Access Compliance Report

Public Rights-of-Way

(Curb Ramps)

Intersection ID: 13037	Main Street: S_CHURCH_ST	Cross Street: QUINCEY_ST	Location: E
ADA ID: F0D5DAEE880F	Ramp Type: Perp	Initial Pass/Fail: Fail	Overall Compliance: No
Severity Score: 21.25			
Codes/Mitigation Info/Possible Solution		Field Measurements/Component Compliance

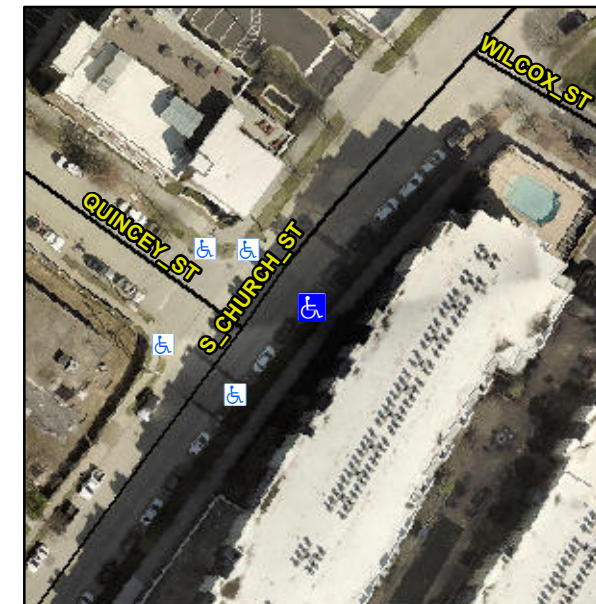
R304.5.1, R304.2.2

Compliance	Description	Data	Compliance	Description	Data
N/A	Ramp Length (in)	96.0	No	Ramp Slope (%)	9.9
No	Ramp Width (in)	47.0	Yes	Ramp XSlope (%)	1.6
N/A	Flare Type LT	N/A	N/A	Flare Type RT	N/A
N/A	Flare Slope LT (%)	N/A	N/A	Flare Slope RT (%)	N/A
N/A	Flare Traversable LT?	N/A	N/A	Flare Traversable RT?	N/A
N/A	Landing Length (in)	N/A	N/A	DWS Provided?	N/A
N/A	Landing Width (in)	N/A	N/A	DWS Contrast?	N/A
N/A	Landing Slope (%)	N/A	N/A	DWS Length (in)	N/A
N/A	Landing X Slope (%)	N/A	N/A	DWS Full Width?	N/A
N/A	Landing Curb? (Y/N)	N/A	N/A	DWS Offset (in)	N/A
N/A	Shared Landing?	N/A			
N/A	Gutter Ponding?	N/A	N/A	Gutter Slope (%)	N/A
N/A	Gutter Lip Ht (in)	N/A	N/A	Gutter X Slope (%)	N/A
N/A	Painted X Walk1?	No	N/A	Painted X Walk2?	N/A
	X Walk 1 Direction	To NW		X Walk 2 Direction	N/A
N/A	X Walk 1 Width (in)	N/A	N/A	X Walk 2 Width (in)	N/A
	X Walk 1 Slope (%)	2.3		X Walk 2 Slope (%)	N/A
	X Walk 1 X Slope (%)	3.4		X Walk 2 X Slope (%)	N/A

Remove & Replace Entire Ramp.
